CITY OF PANAMA CITY BEACH
August 24, 2023

ADDENDUM NO. 1

**PCB23-48 ITB
FIRE STATION #32**

This addendum modifies Fire Station #32 Bid Documents dated August 1, 2023

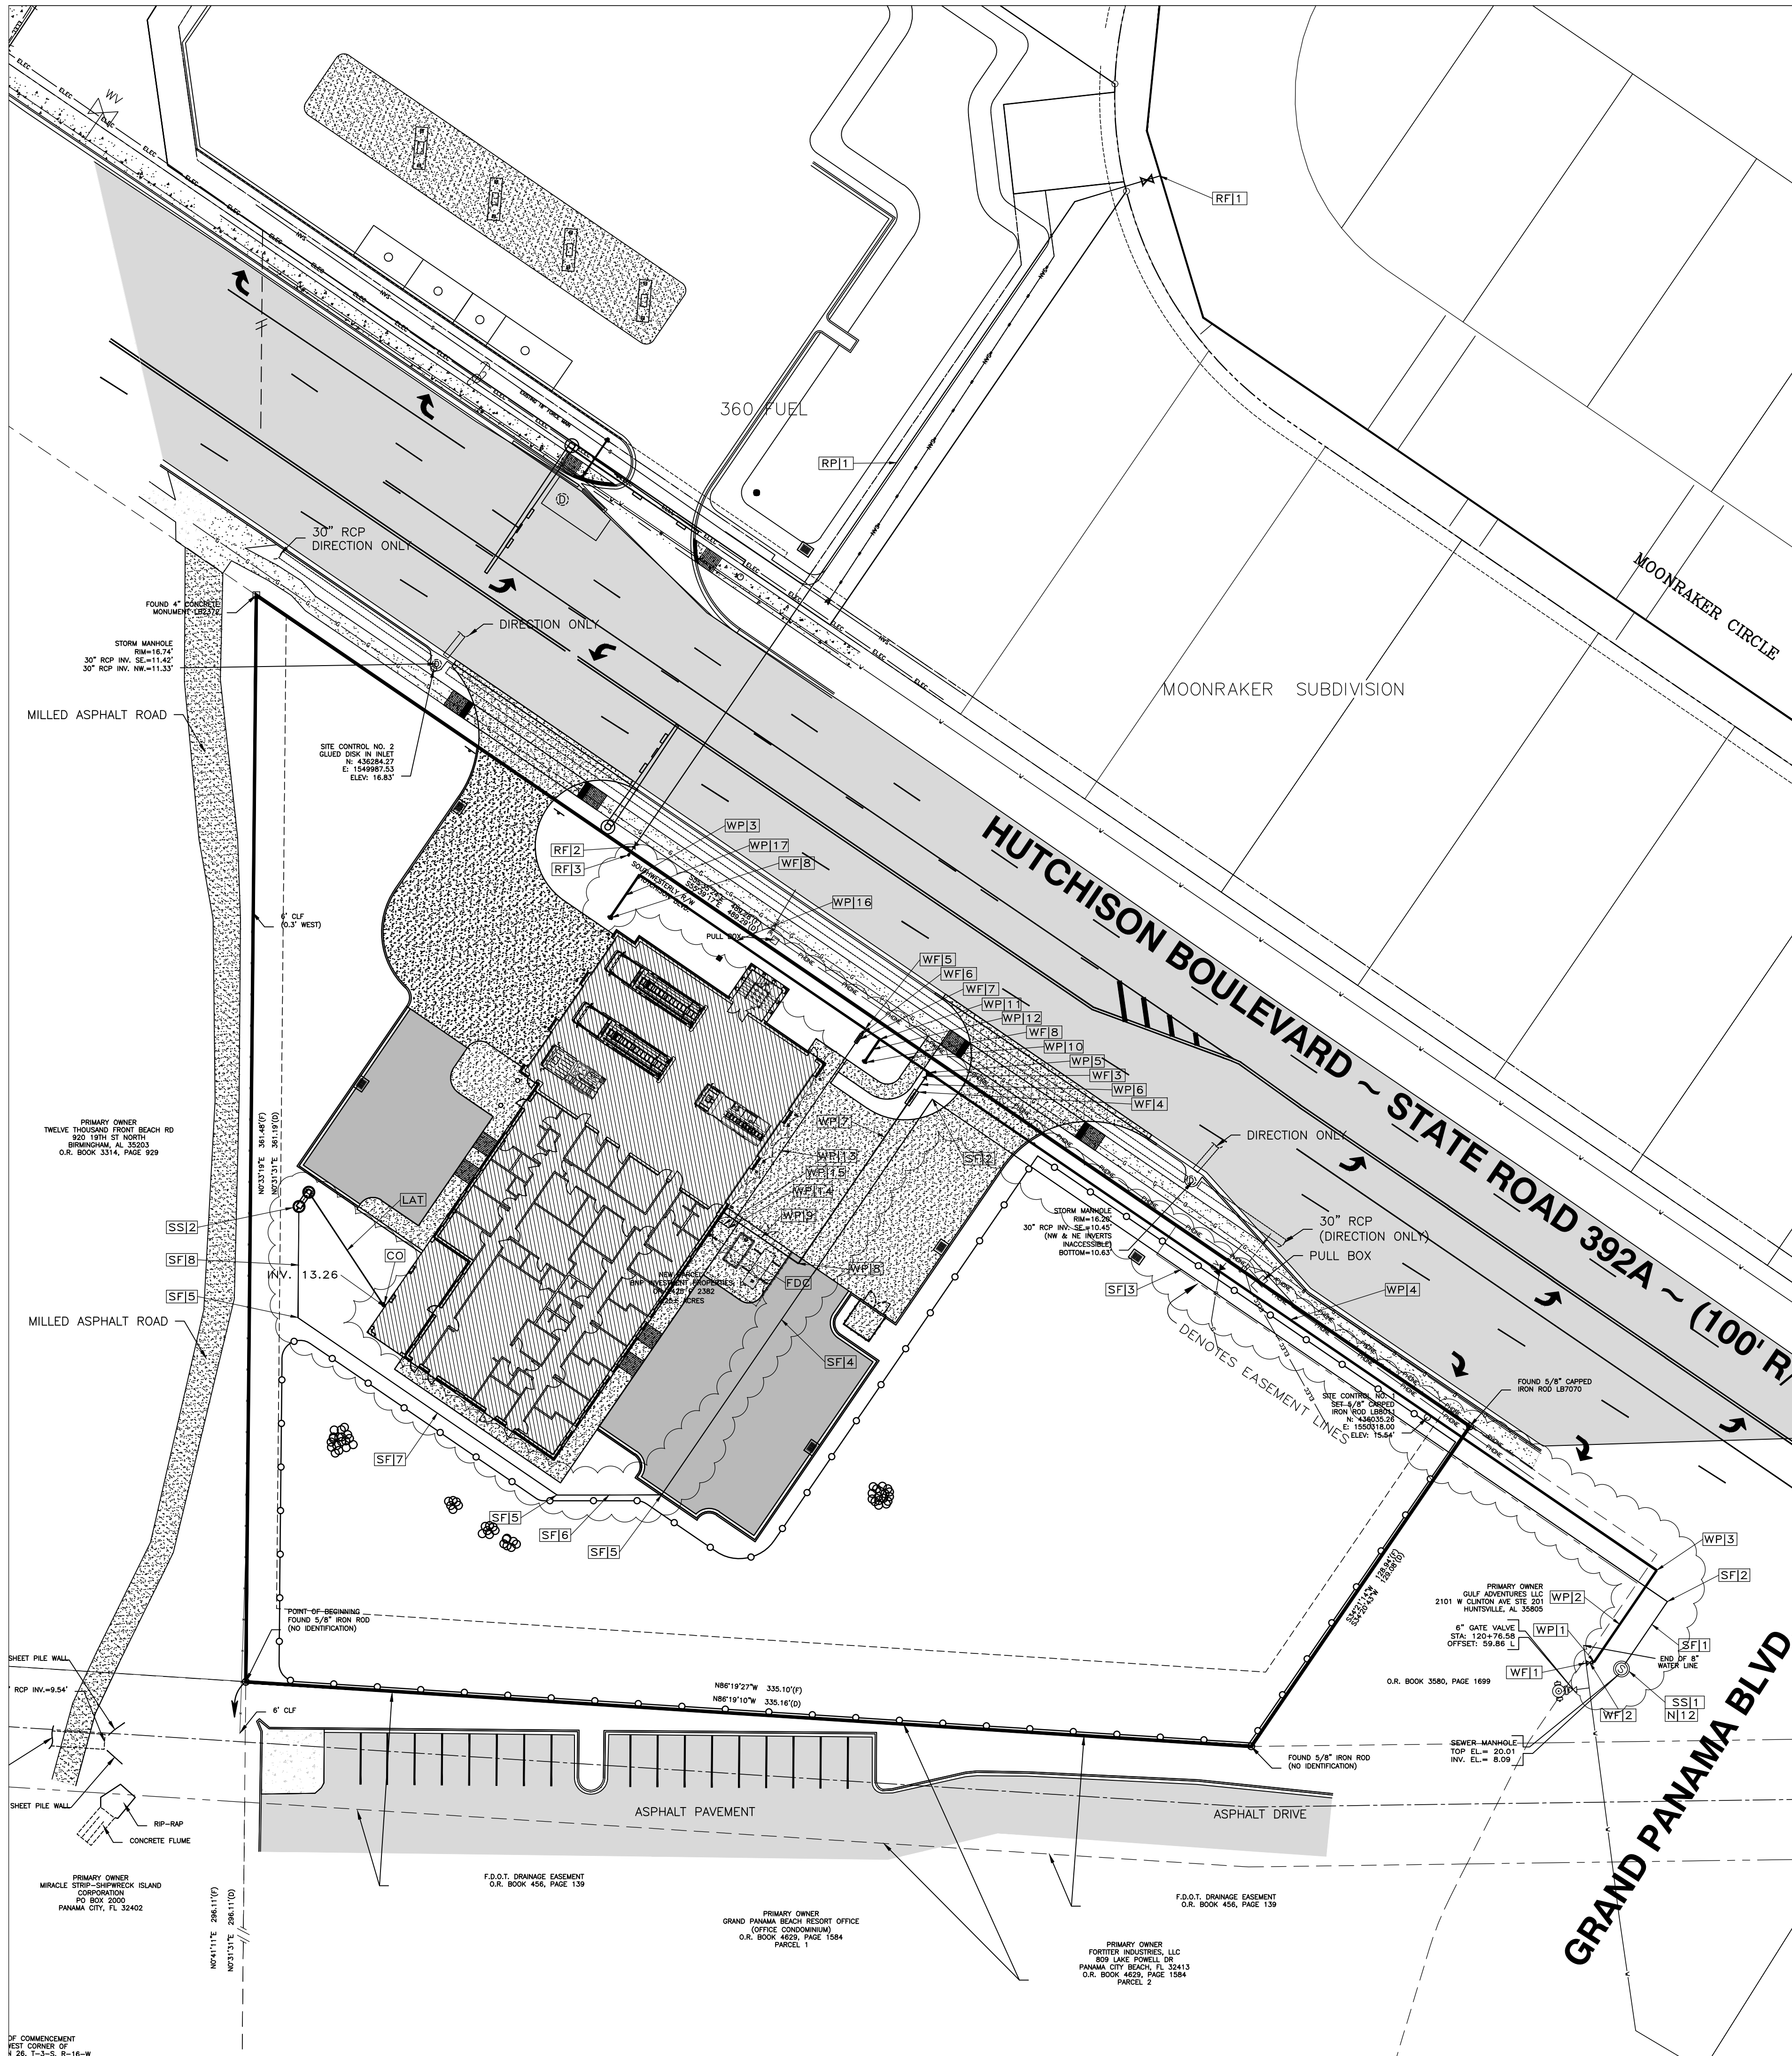
23. The fence at the rear of the property line does not match up with the fence on the left side of the retention pond; please see attached page c1.6 and please advise.

A. Extend fence line along west side of pond southward to meet fence line along the south property line. South fence stops and connects to west fence line.

C1.6

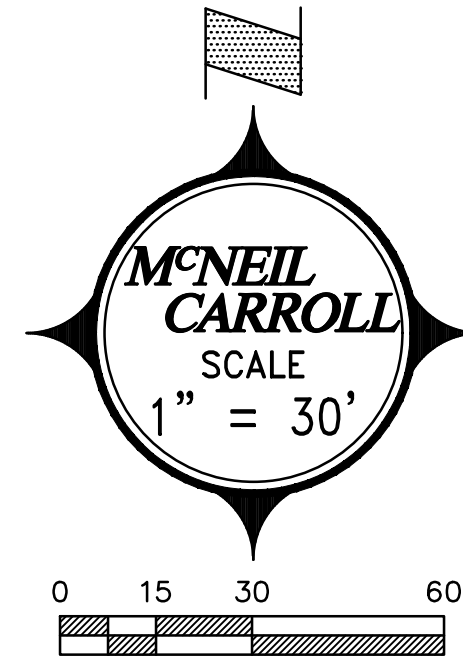
24. Revise: Sheet C1.6 to shift two fire hydrant locations and adjust associated fire main, BFP, etc.:

Replace Sheet C1.6 in its entirety with new sheet C1.6, Revision #1 dated 08/24/23 (Attachment #1).

NO.	DESCRIPTION	DRAWN	CHECKED	DATE
01	UPDATED WATER & FORCE MAIN LOCATION			08/24/23
